Re: Australian Seaweed Institute Project Proposal

Queensland Seafood Industry Association submission regarding Seaweed Australia Institute's Moreton Bay Seaweed Aquaculture Proposal

Figure 1. Project footprint.

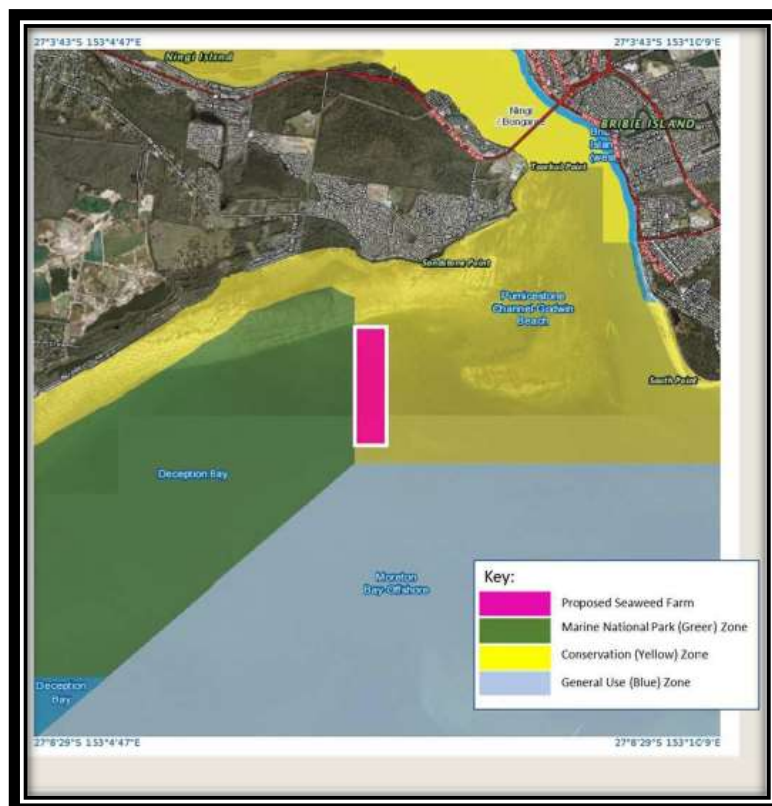
It is difficult to understand how the Australian Seaweed Institute can propose a commercial project in the middle of a Yellow Zone in the Moreton Bay marine park or that it is being considered by the State Government.

A key question for the State Government is: How then is a 60-hectare project proposal situated in a Yellow Zone and adjacent to a Green Zone in a State marine park allowable?
